Subject: Responses to Comments in *Notice of Disapproval: Environmental Restoration Project Consolidated Quarterly Report, September 2010*

**Document title:** DOE/Sandia Responses to the NMED's Comments in "Notice of Disapproval: Environmental Restoration Project Consolidated Quarterly Report, September 2010"

**U.S. Department of Energy/Sandia Corporation Responses  
to the New Mexico Environment Department's Comments  
in  
"Notice of Disapproval, Environmental Restoration Project  
Consolidated Quarterly Report, September 2010  
Sandia National Laboratories,  
EPA ID# NM5890110518, HWB-SNL-10-016"**

**Figure A-3**  
**Potentiometric Surface Map for the**  
**Chemical Waste Landfill, March 2010**

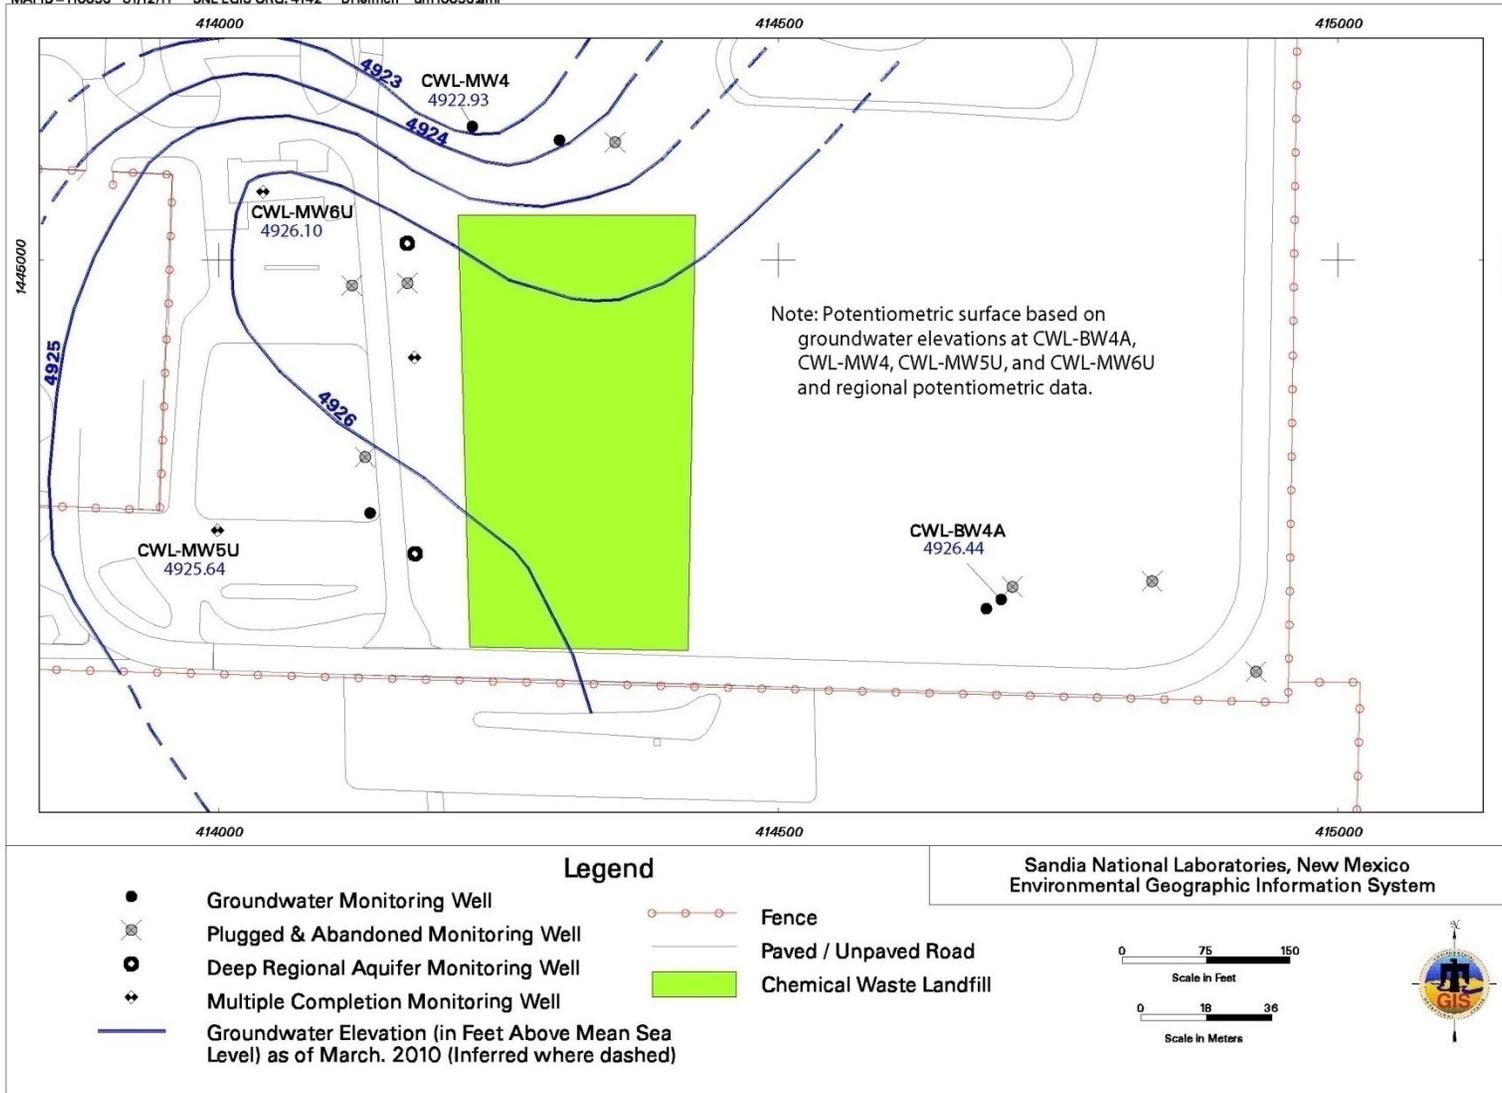
4. **The Permittees must submit a potentiometric surface map for the Chemical Waste Landfill based on groundwater levels measured during the particular reporting period in the CQ Report and future reports.**

Response: The requested potentiometric surface map, showing groundwater elevation as of March 2010, addresses this change and is provided in Attachment C as Figure A-3. Updated potentiometric surface maps will be provided with future CQ Reports in Appendix A of Section II.

New Figure, Figure A-3  
Potentiometric Surface Map for the Chemical Waste Landfill, March 2010
